ADDENDUM No. 3 TO PROCUREMENT CONTRACT DOCUMENTS
BRIDGEPORT PUBLIC UTILITY DISTRICT (BPUD)

Arsenic Removal Project – Arsenic Removal System Procurement Contract

May 17, 2017

Bridgeport Public Utility District – Arsenic Removal Project

NEW PUMP DISCHARGE DETAIL

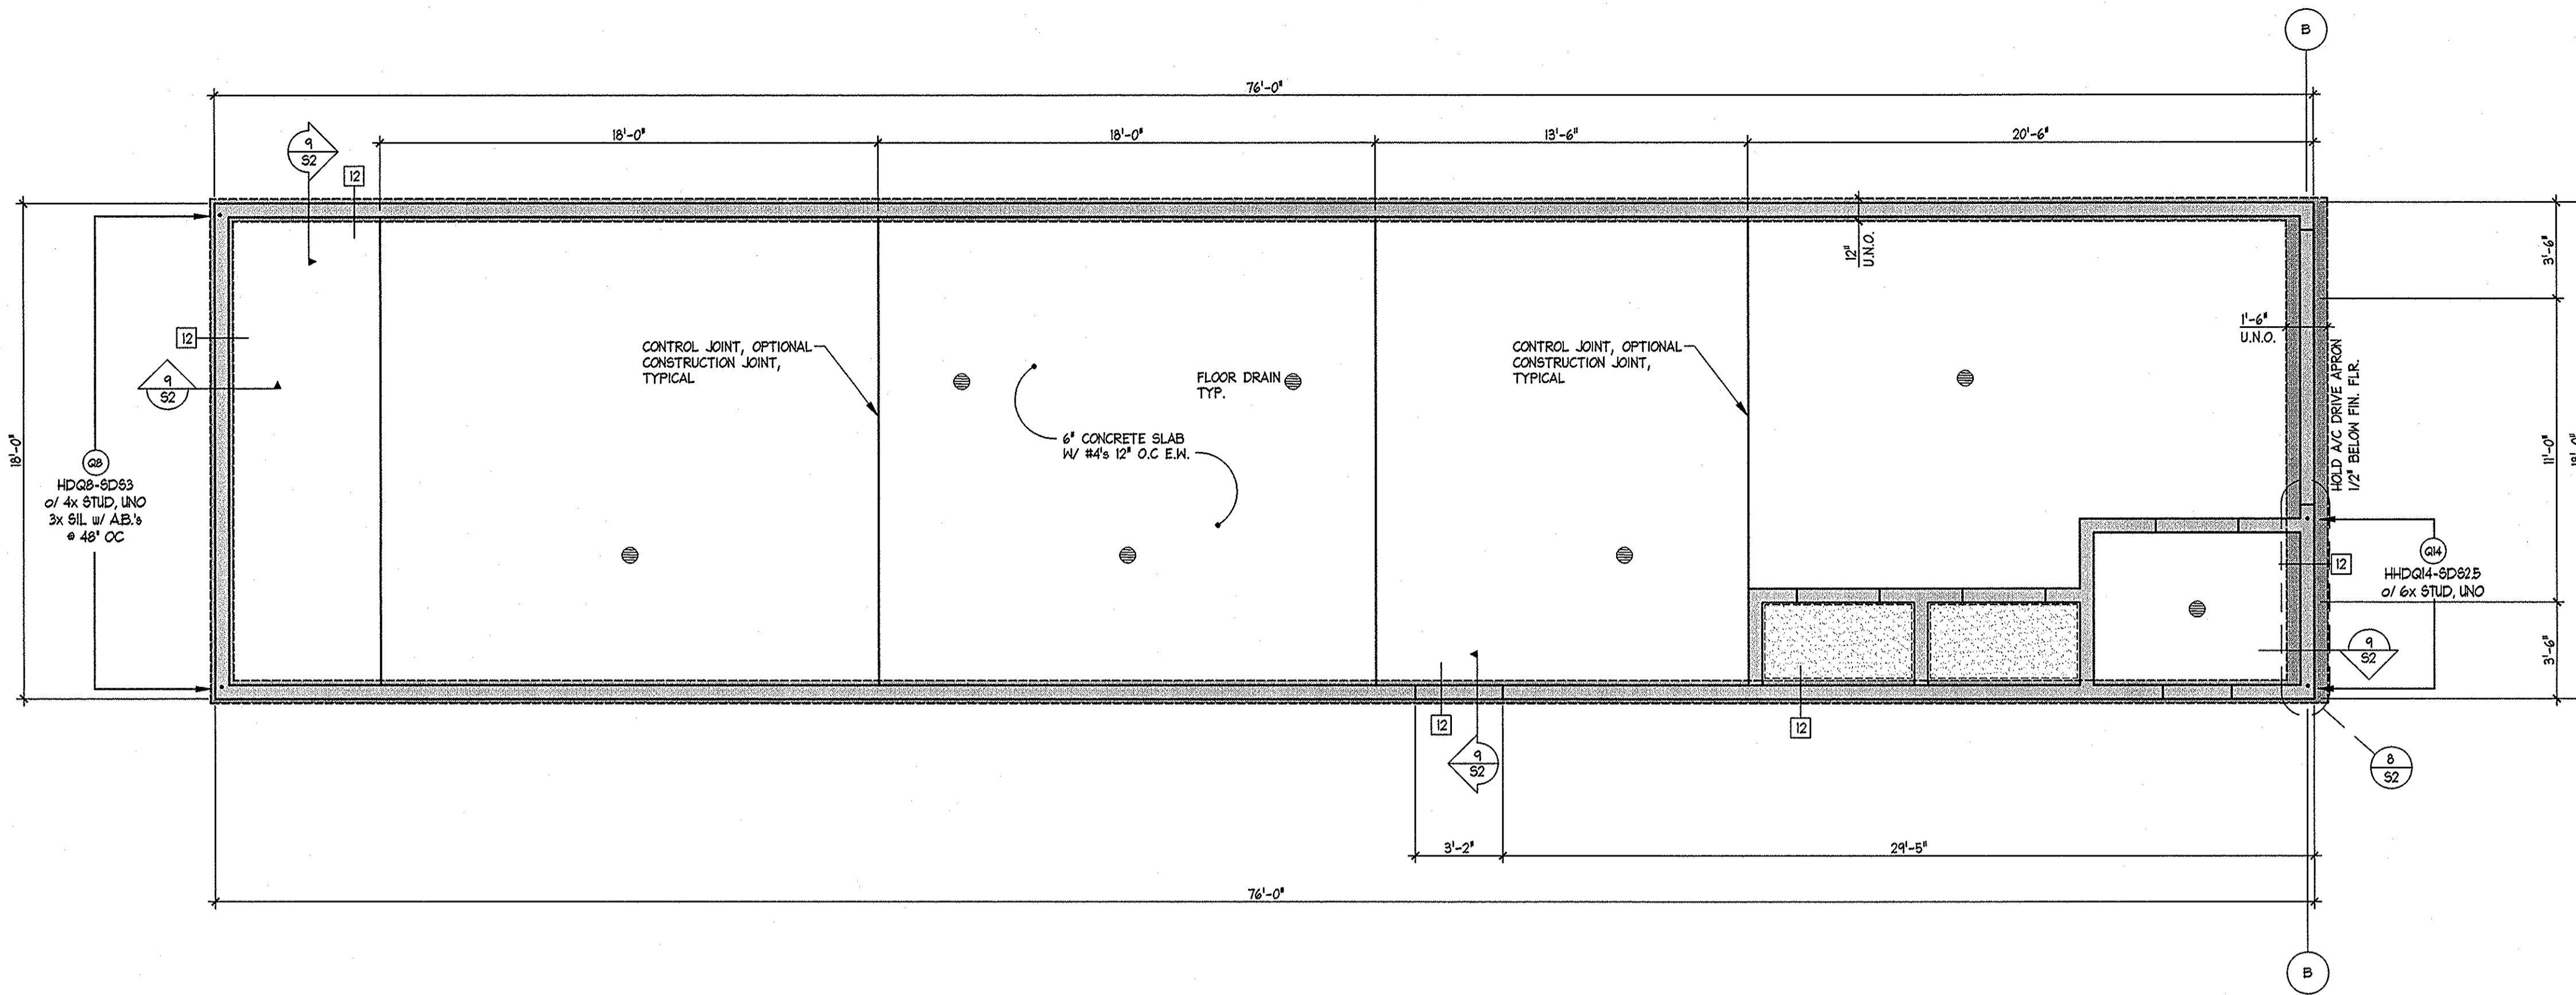
1. Entire new sheet requiring changes to the well discharge and a new building.
